CROSSROADS NORTH

PRELIMINARY PLAN

COVER
SHEET 01 OF 14

PRELIM PLAN 1
SHEET 02 OF 14

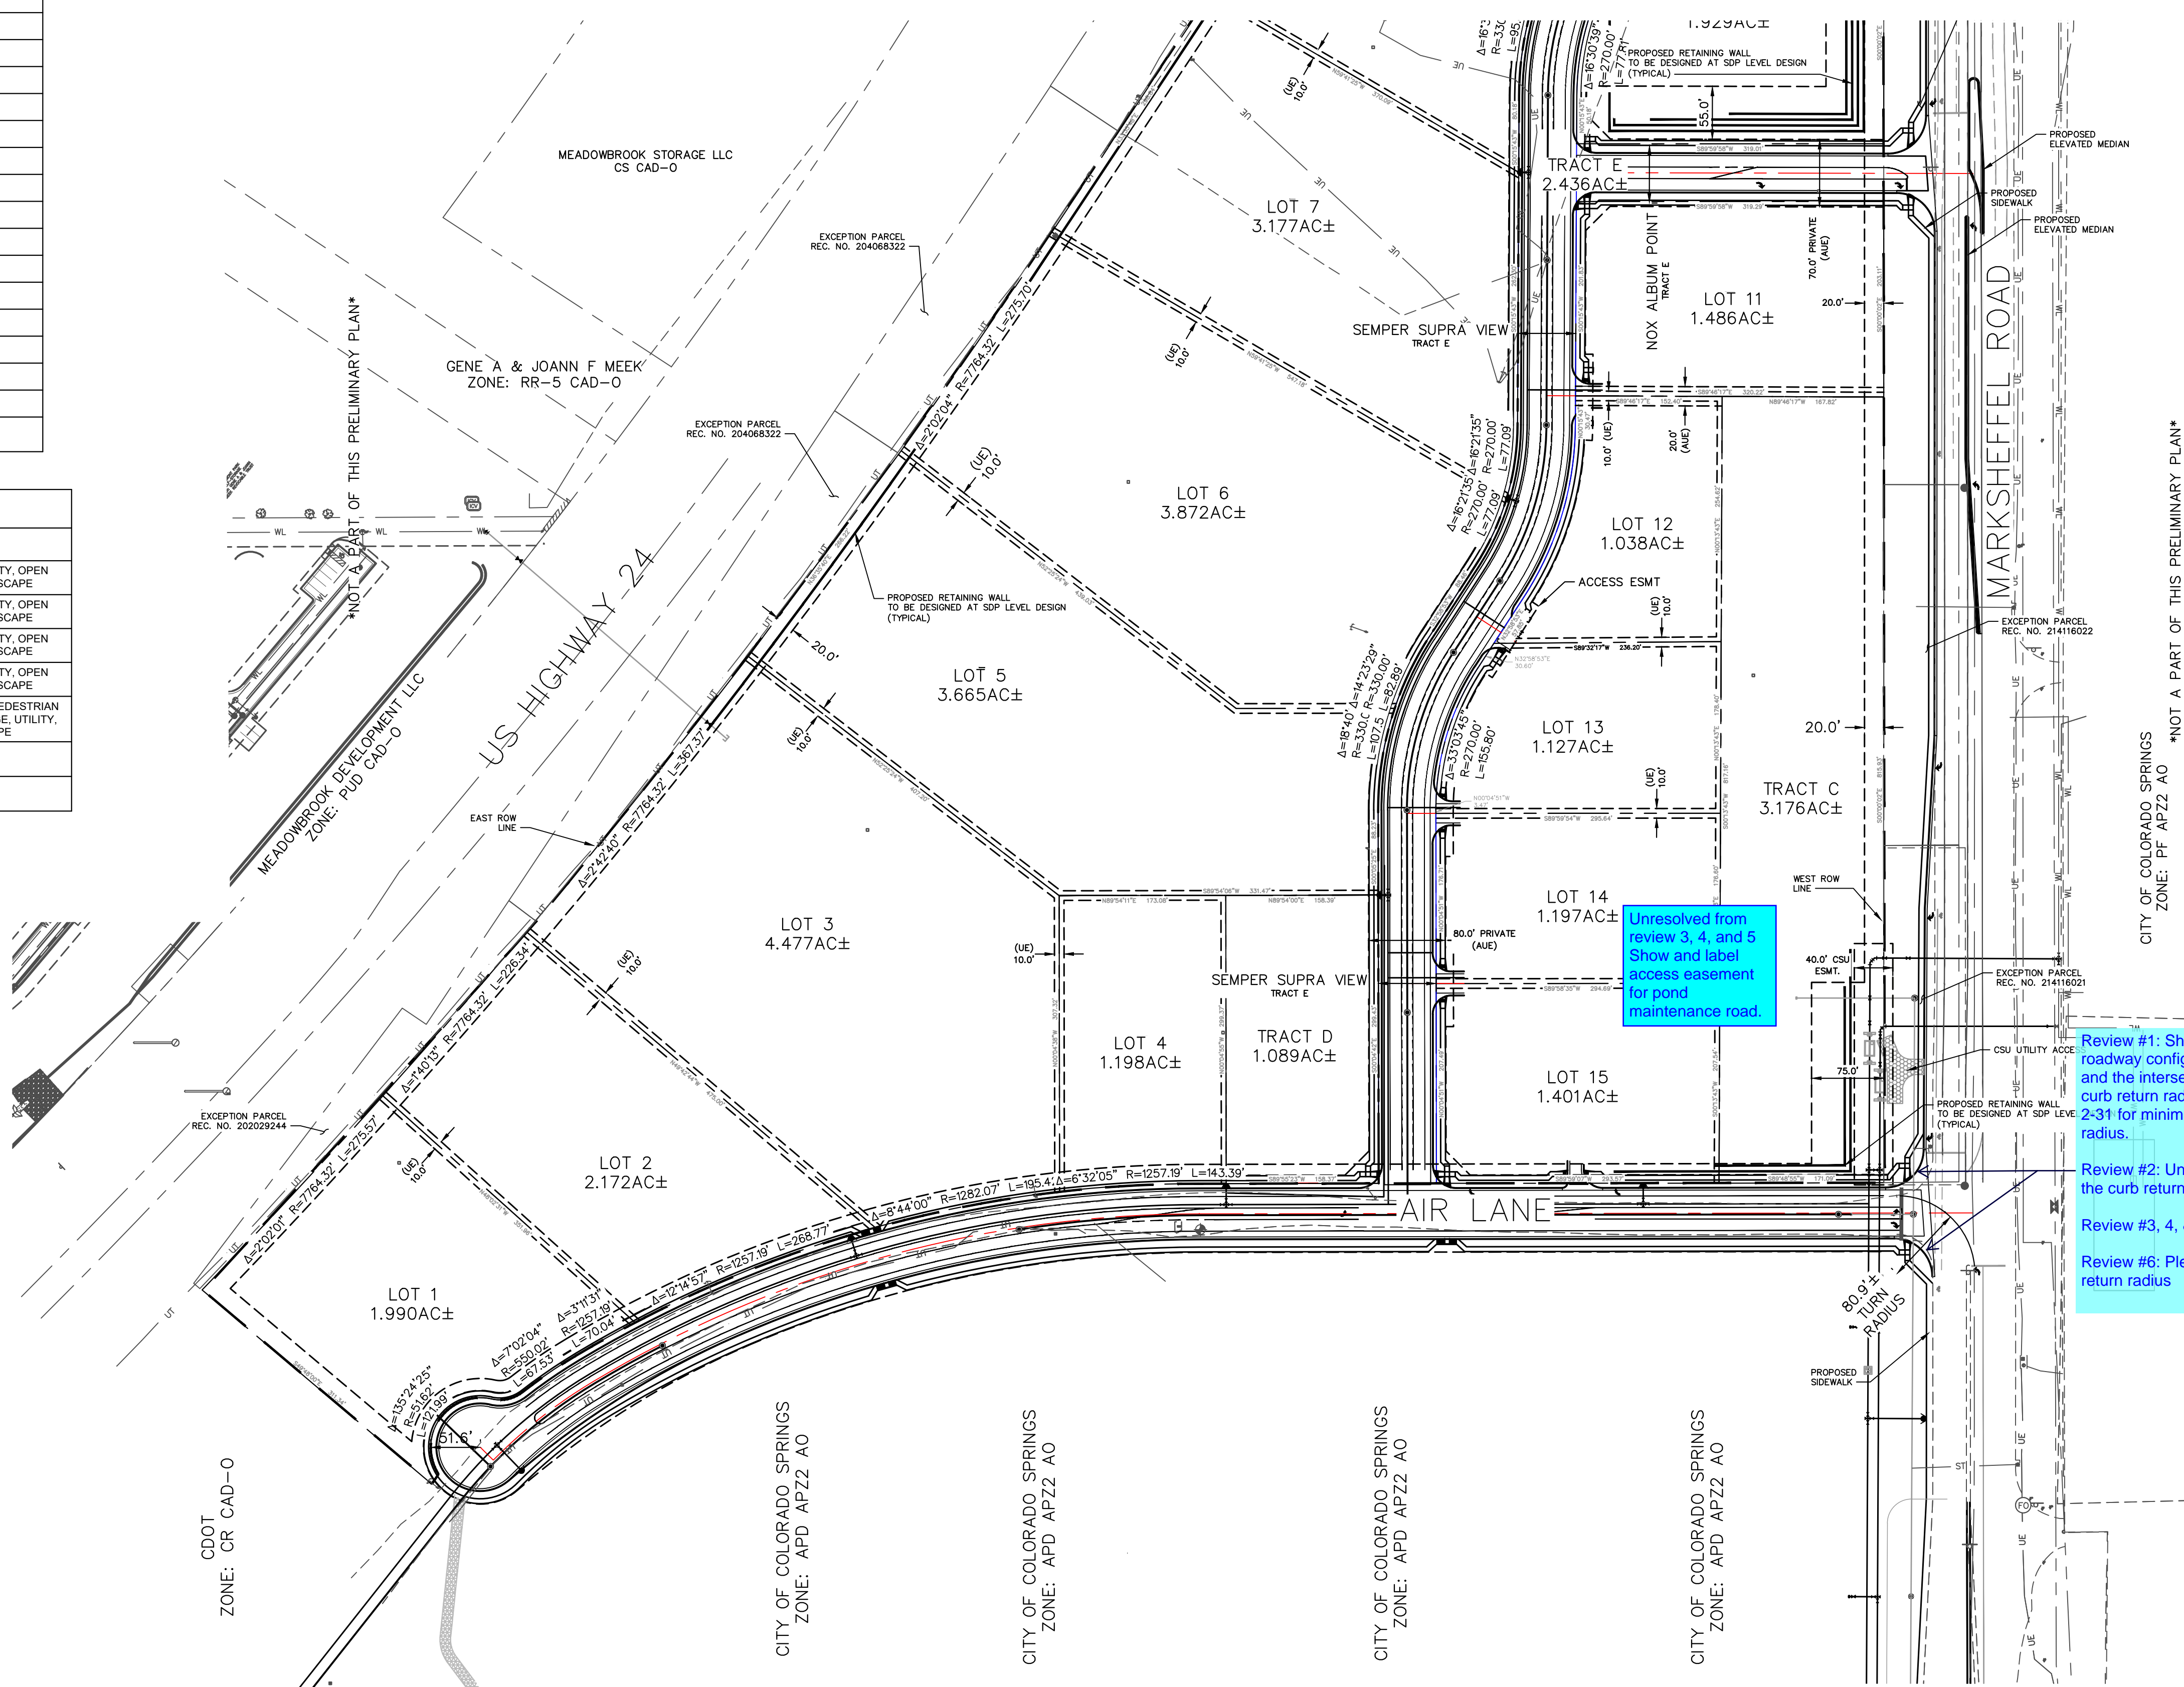
Is this a park site? It is still not clear.

PRELIM PLAN 2
SHEET 03 OF 14

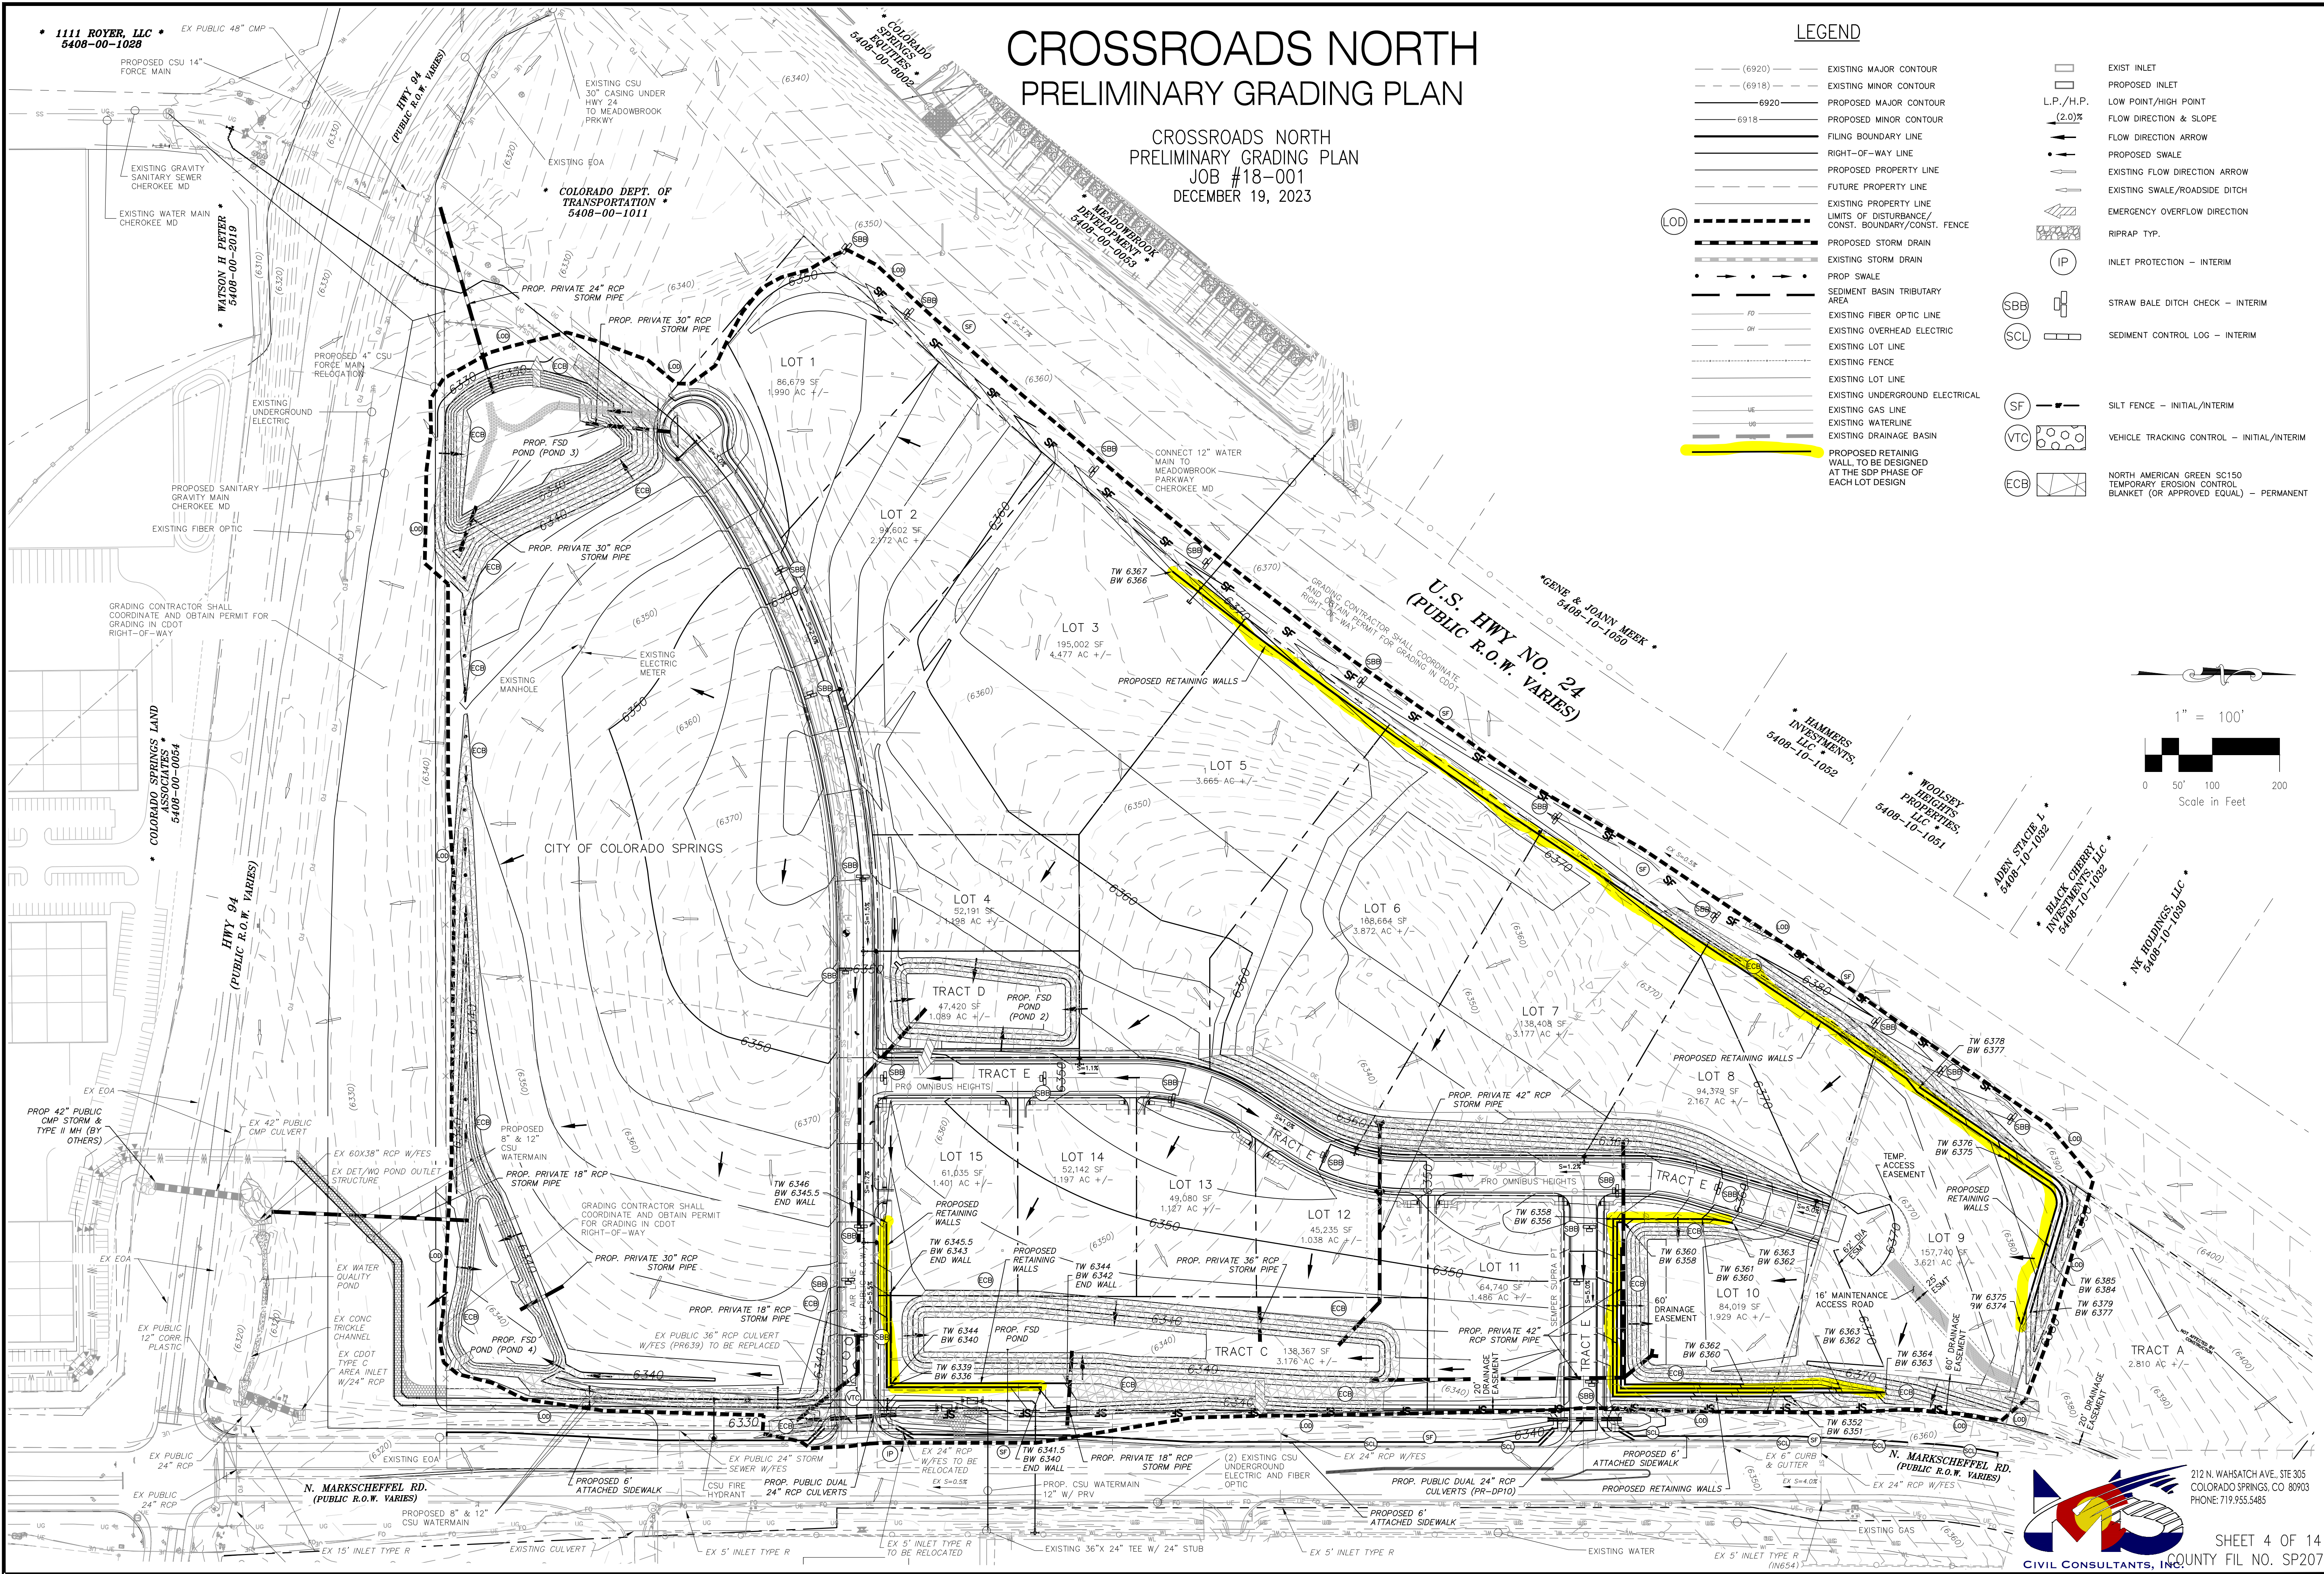
Unresolved from review 3, 4, and 5
Show and label access easement for pond maintenance road.

Review #1: Show the proposed roadway configuration of Air Lane and the intersection. Label the curb return radius. See Table 2-31 for minimum curb return radius.
Review #2: Unresolved. Label the curb return radius.
Review #3, 4, & 5: Unresolved.
Review #6: Please label the curb return radius.
